TOWN OF APPLE VALLEY

SITE PLAN REVIEW 2015-001

MITIGATED NEGATIVE DECLARATION (SCH #2016041058)

RESPONSE TO COMMENTS

Response A-2 The location of the site is clearly identified in the referenced Ordnance Report, and correctly described in the IS/MND. A reproduction of Figure 4 of the Ordnance Report is provided below.

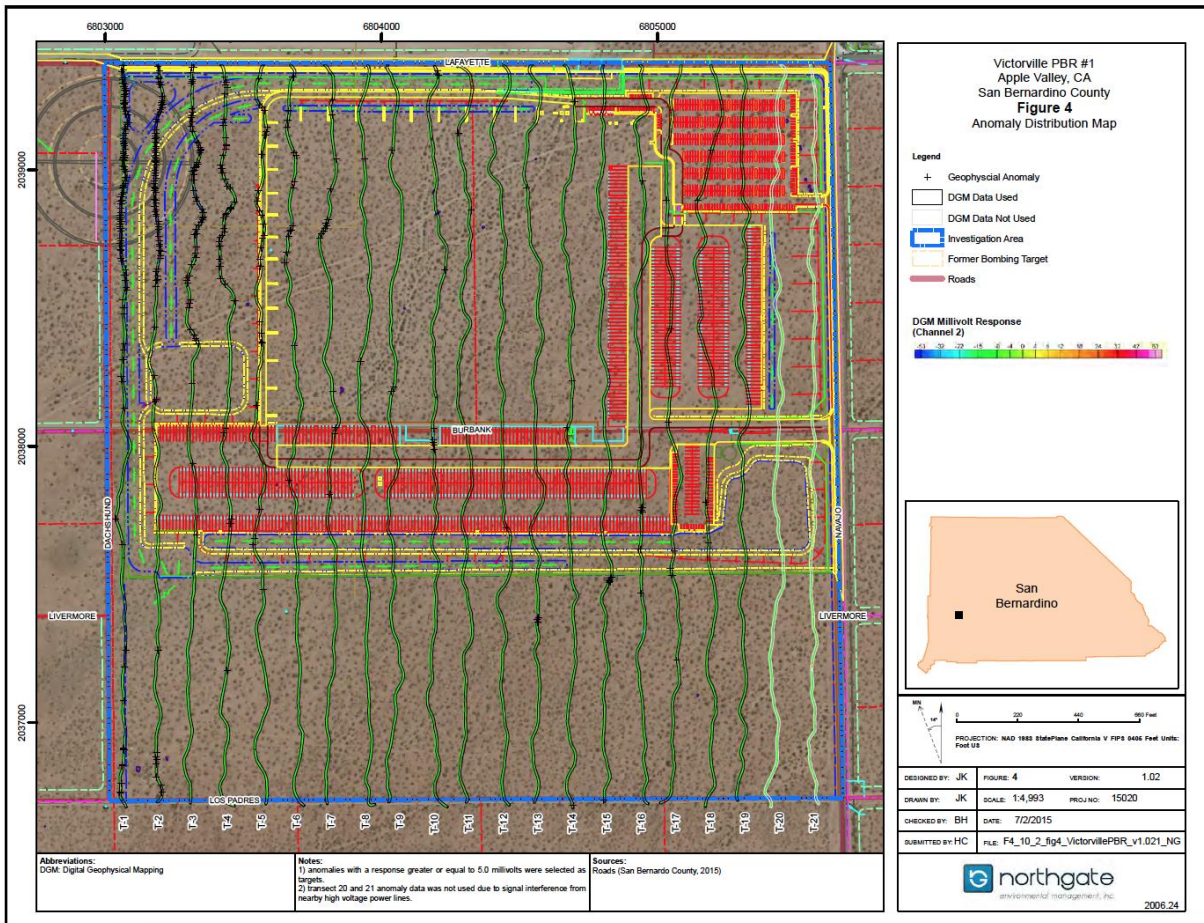
1. Section VII, Hazards and Hazardous Materials - This section of the IS/MND describes a portion of the Project site as being part of a larger area formerly used as a practice bombing range for military training purposes during the 1940's. The boundaries of the former bombing range were not delineated in the IS/MND, rather the location was roughly identified as the northwest corner of the site.

A review of the Water Board's GeoTracker database indicates that the Project site was part of a larger "Formerly Used Defense Site" (FUDS) subject to cleanup requirements under the oversight of the California Department of Toxic Substances Control (DTSC [Site ID.No. 80000405]). This is consistent with the reported former land uses

described in the IS/MND. Based on the information provided in the NOI, it does not appear that DTSC was provided a copy of the IS/MND for review and comment. We request that the lead agency consult with and request comments from DTSC with respect to the proposed development of this site.

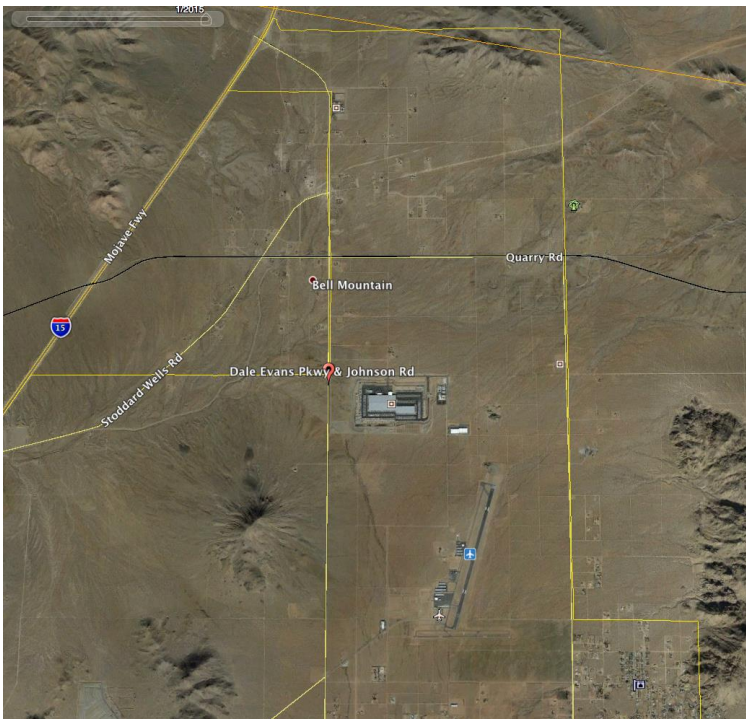
The traffic analysis downplayed the true extent of traffic impacts by using both aspirational roadway conditions and outdated traffic

conditions. Therefore, the baseline from which the Project's traffic impacts were analyzed fails to represent accurate conditions presently surrounding the Project. This improper baseline ultimately "mislead(s) the public" by engendering skewed and inaccurate analyses of environmental impacts, mitigation measures and cumulative impacts for biological resources. See *San Joaquin Raptor Rescue Center*, 149 Cal.App.4th at p. 656; *Woodward Park Homeowners*, 150 Cal.App.4th at 708-711. Without an accurate baseline, the IS/MND's conclusion that the Project's traffic impacts will be less than significant are unsubstantiated. Proper analysis must be conducted to take into account present day conditions, and all impacts must be mitigated. An EIR must be prepared to remedy these deficiencies.

Response H-4 The commenter claims that the MND contains an insufficient description of the baseline environmental conditions against which impacts are measured. This is incorrect because the commenter inappropriately references the standard for assessing a project's environmental setting where a lead agency is preparing an EIR. That is, the commenter fails to recognize that CEQA establishes a less-stringent standard for describing baseline conditions where a lead agency is considering approving a project via a negative declaration. (See State CEQA Guidelines, § 15071 [requiring MNDs to describe "[t]he location of the project, preferably shown on a map"]; *Fat v. County of Sacramento* (2002) 97 Cal.App.4th 1270 [finding that an agency's description of a project's existing environmental setting in a negative declaration will be valid so long as the agency's description "represents an objective, good faith effort to comply with CEQA"].)
